This revised Part 2 describes proposed revisions to the Pre-2006 Projects for the Everglades Construction Project (ECP) basins which were included in the October 27, 2003 *Everglades Protection Area Tributary Basins Long-Term Plan for Achieving Water Quality Goals* (Long-Term Plan). The hydrologic basins addressed in this Part 2 are listed in Table 2.1; an overview of the project area is shown in Figure 2.1.

The projects in the October 27, 2003 Long-Term Plan were designed to achieve compliance with the water quality standards for the Everglades Protection Area (EPA) by December 31, 2006, based on specific assumptions and the best available information. The Long-Term Plan was submitted on December 19, 2003, to the Florida Department of Environmental Protection (FDEP) in accordance with the Everglades Forever Act (EFA) requirement (Section 373.4592 (10)(a), F.S.) as part of the District’s application for a permit modification needed to implement the Long-Term Plan. This revised Part 2 of the Long-Term Plan is being submitted to the FDEP as part of an amended application for permit modification. The application is being amended to include authorization for the proposed revisions to

Figure 2.3 Schematic Diagram of Enhanced STA-1E

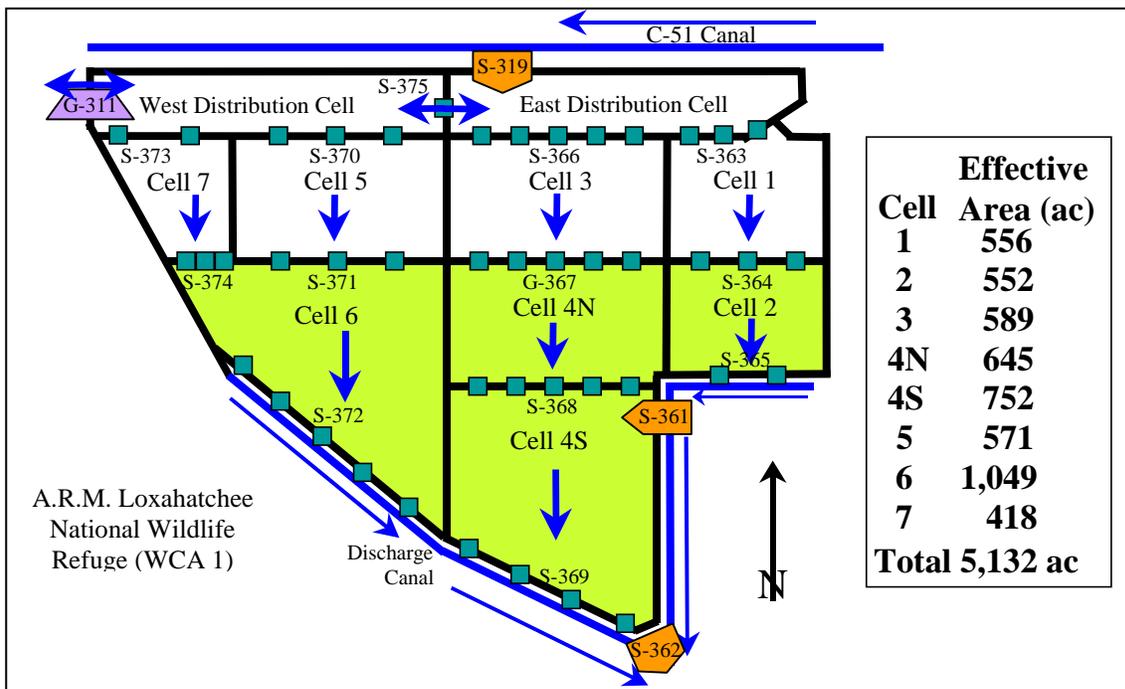
A schematic diagram of STA-1E is presented in Figure 2.3.

In Figure 2.3, those areas recommended for conversion to SAV are shown shaded.

Figure 2.6 Revised Schematic Diagram of Enhanced STA-1W

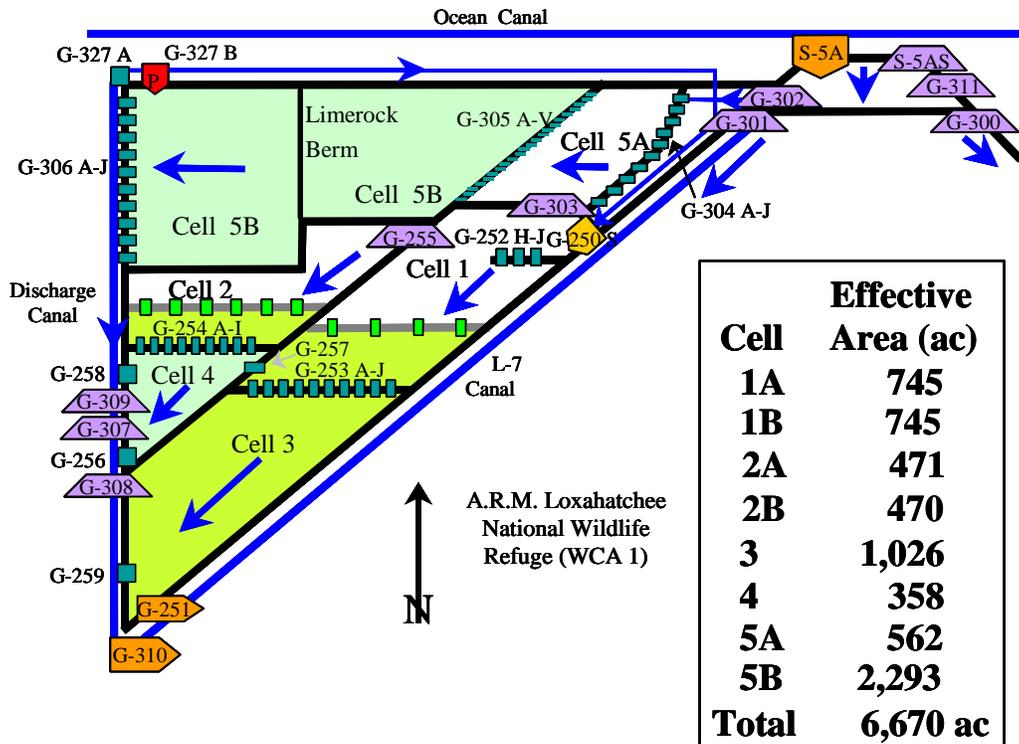
The following are improvements and enhancements proposed to be implemented in addition to those in the October 27, 2003 Long-Term Plan described above:

- Removal of flow obstructions is also proposed in Cells 2 and 4 to improve flow distribution within the treatment cells.
- Modified water control structures in the new Cell 2 levee. The October 27, 2003 Long-Term Plan anticipated six (6) 84-inch diameter corrugated metal culverts with stop log risers in the new levee. This was changed during the detailed design to eight (8) each 8-ft wide by 4-ft high concrete box culverts with stop log risers.

- Removal of vegetative tussocks in an approximate 230-acre area in Cell 2.
- Revised location for proposed pump station G-327B as described above.
- The addition of recreational facilities is proposed to provide public access to STA-1W. The proposed facilities include an asphalt parking area on the south side of CR 880 and associated road improvements such as an acceleration and deceleration land in the vicinity of the entrance to the parking lot. The proposed facilities include a canoe launching site and a boardwalk for access to the seepage canal north of the STA. A footbridge is also proposed across the seepage canal to provide pedestrian access to the existing leveled area adjacent to the north end of the limerock berm in Cell 5B. An information kiosk, a viewing tower, a composting toilet, a picnic shelter and landscaping are proposed at this location. Pedestrian gates, signage and fencing as needed to define public access areas and to protect sensitive equipment are also proposed.

A revised schematic diagram of STA-1W, modified as recommended herein, is presented in Figure 2.6.

In Figure 2.6, those areas presently developed in SAV are shown lightly shaded; those additional areas recommended for conversion to SAV are shown in slightly darker shading.

Figure 2.9 Schematic of Enhanced STA-2

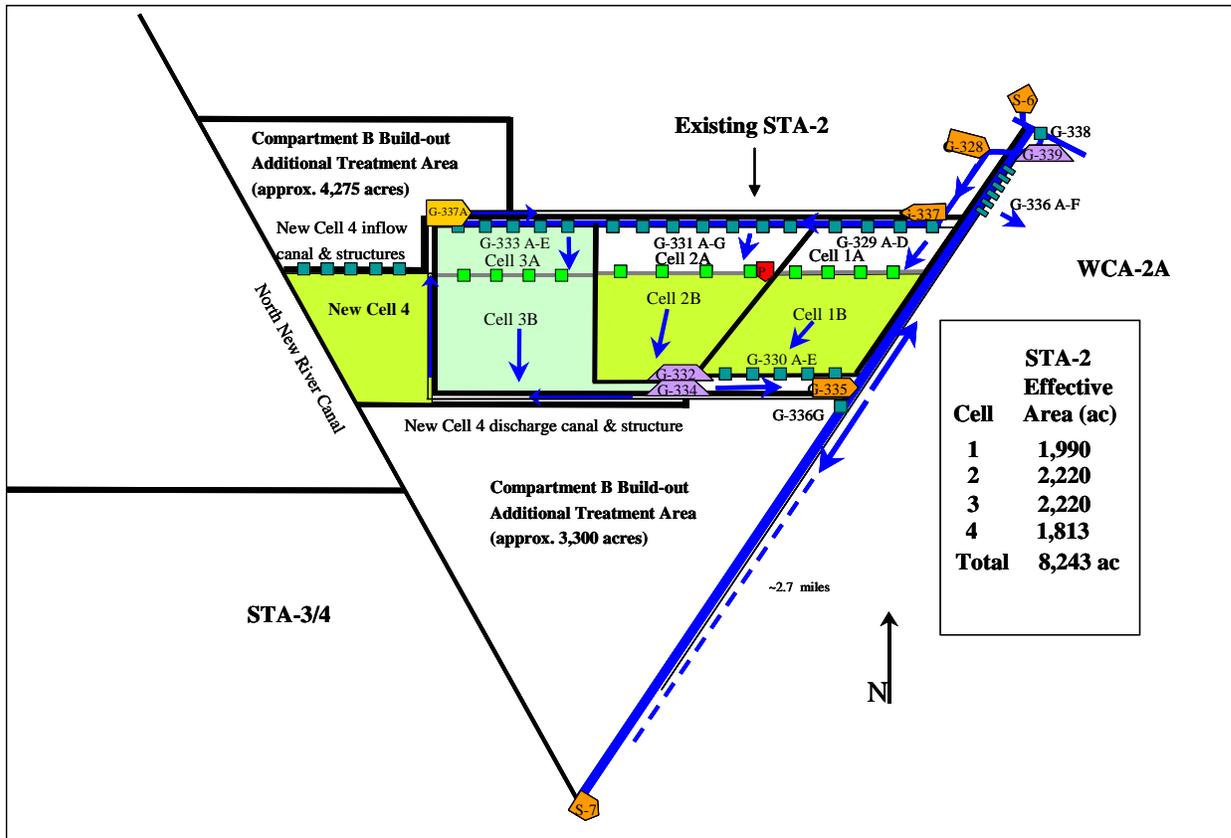
In addition to the above recommended improvements, as a result of the recent availability of land adjacent to STA-2, it is proposed to initially expand STA-2 with a new parallel treatment cell, i.e., Cell 4. The following assumptions were used to develop a conceptual plan for this initial expansion of STA-2; if any of these assumptions are incorrect, unavoidable delays to the project could result:

water to the north end of Cell 4. The eastern levee of the North New River Canal will serve as the new Cell 4 western levee. Cell 4 will be developed as an SAV cell identical to Cell 3, and a new discharge canal will convey treated water south of the existing Cell 3 by expanding the existing seepage collection canal. A new Cell 4 outlet control structure (similar to G-334) will be constructed at the confluence of this new discharge canal and the existing canal immediately east and downstream of G-334. The need for seepage control will be evaluated in light of the scheduled cessation of farming on adjacent lands. If needed, seepage control will be provided by collection canals along the northern and southern boundaries of Cell 4 with direct connections to the North New River Canal. Approximately 2.5 miles of perimeter levees, six gated water control structures and one spillway will comprise the major construction features. A schematic of the expanded and enhanced STA-2 is provided in Figure 2.9.

In Figure 2.9, those areas presently developed in SAV are shown lightly shaded; those additional areas recommended for conversion to SAV, including the new Cell 4, are shown in slightly darker shading.

Figure 2.12 Schematic Diagram of Enhanced STA-3/4

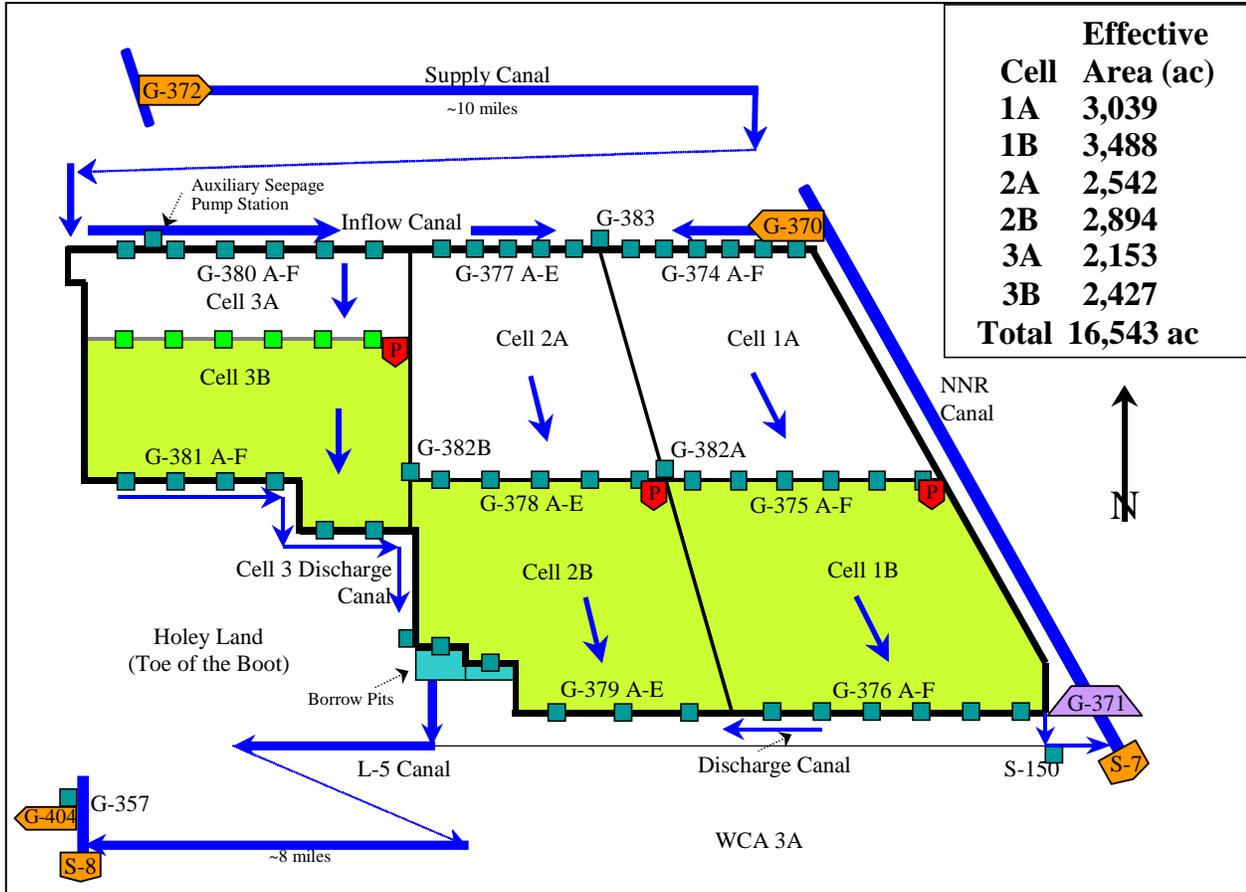
The following improvements and enhancements are proposed in addition to those in the October 27, 2003 Long-Term Plan:

A schematic diagram of STA-3/4, enhanced as recommended herein, is presented in Figure 2.12.

In Figure 2.12, those areas recommended for conversion to SAV are shown shaded.

Figure 2.15 Revised Schematic of Enhanced STA-5

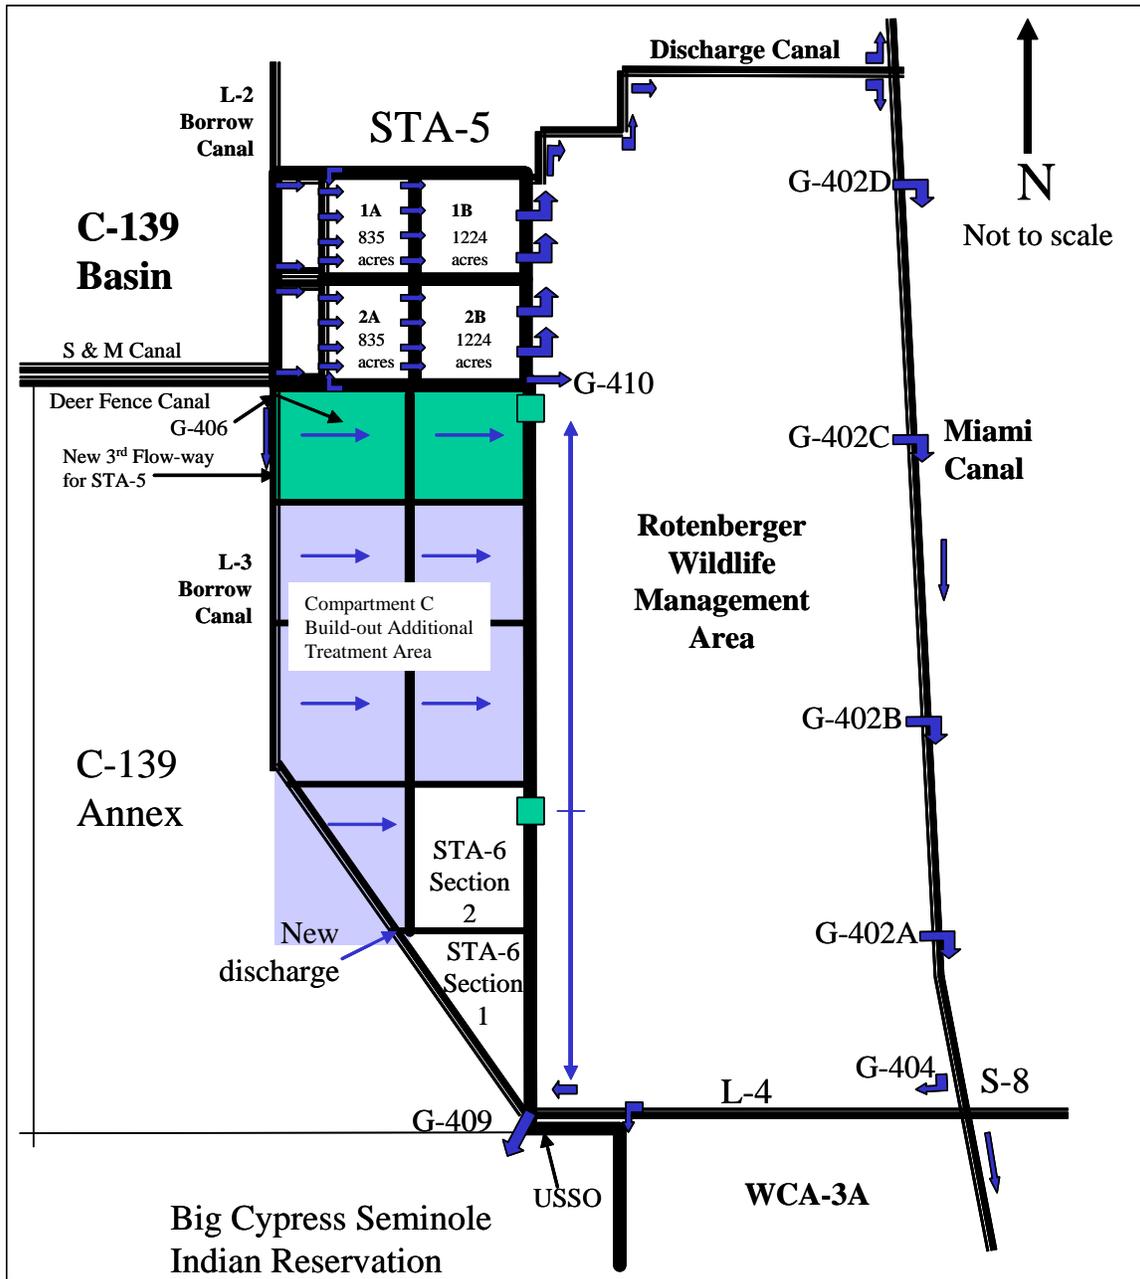
The following revisions are proposed to the October 27, 2003 Long-Term Plan recommended enhancements and improvements:

It is proposed to immediately expand STA-5 by adding a third parallel flow-way which will reduce the phosphorus load on the current STA-5 footprint and increase operational flexibility for the STA. Approximately 4 miles of perimeter levee, 2 miles of inflow canal, 5 miles of a new discharge canal, and six gated water control structures will comprise the major construction features for the expanded STA-5. A revised schematic of STA-5, expanded as recommended herein is presented in Figure 2.15. STA-5 will be further expanded using the remaining land in Compartment C as depicted in Figure 2.15. The details of this additional treatment acreage are to be developed concurrently with the design of the new third flow-way for STA-5.

Figure 2.18 Schematic of Enhanced STA-6

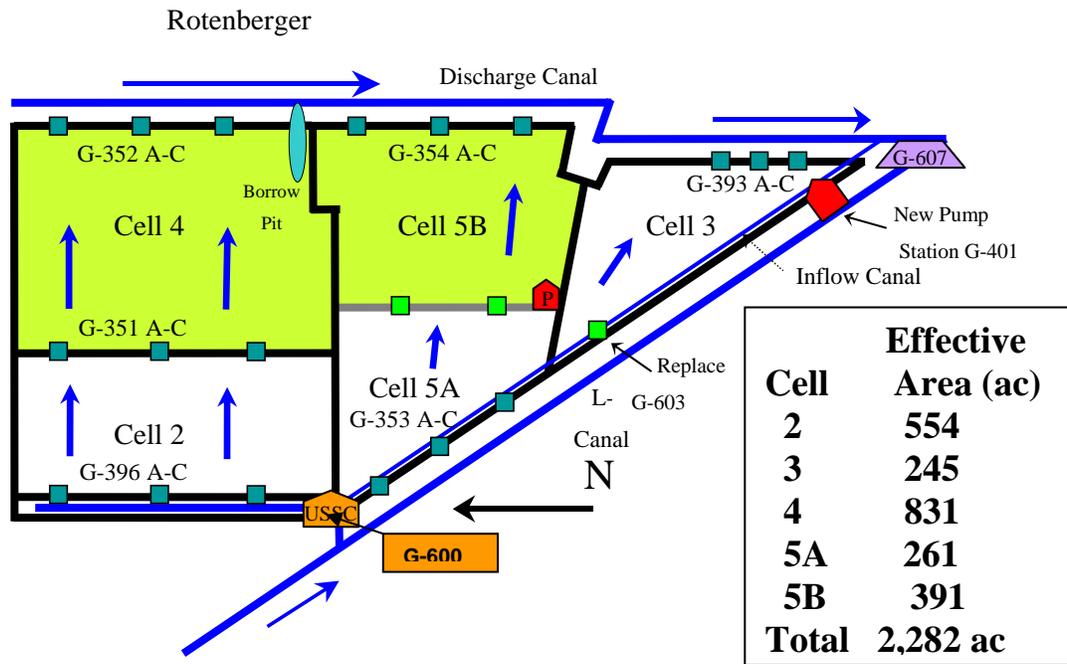
A schematic diagram of STA-6, enhanced and modified as recommended herein, is presented in Figure 2.18.

In Figure 2.18, those areas to be converted to SAV are shown shaded.
